## Task Force SAFE

**Inspection-Report\_TFSAFE\_Full\_KFAB22\_Oiltown-AMOPS\_116\_15-06-26\_1-6**

<b>Base Location</b>	KFAB (Jordan)	<b>Date:</b>	15-JUN-2026
<b>Base Code</b>	KFAB22	<b>Team #:</b>	116
<b>Building #</b>	Oiltown-AMOPS	<b>System Voltage</b>	230/400
<b>Building Type</b>	OFFICE	<b>Inspection Phase</b>	Full Inspection
<b>Previous Report #:</b>	N/A	<b>Work Order:</b>	TFS-KFAB22-2026-00015

<b>Deficiency #1</b>	<b>RAC 2</b>	<b>Occurrences: 1</b>
----------------------	--------------	-----------------------

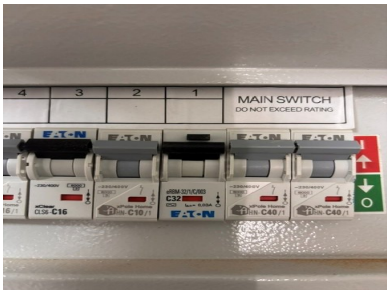
**Description:** Breaker blank missing from dead front.

<b>Location:</b>	At CDP.
<b>Category:</b>	Improper Use / Damaged
<b>Equipment:</b>	CDP
<b>Imminent:</b>	No
<b>Action:</b>	N/A
<b>Assigned To:</b>	O&M; Provider
<b>Code:</b>	British Standard 132: Protection against electric shock
<b>Status:</b>	Open
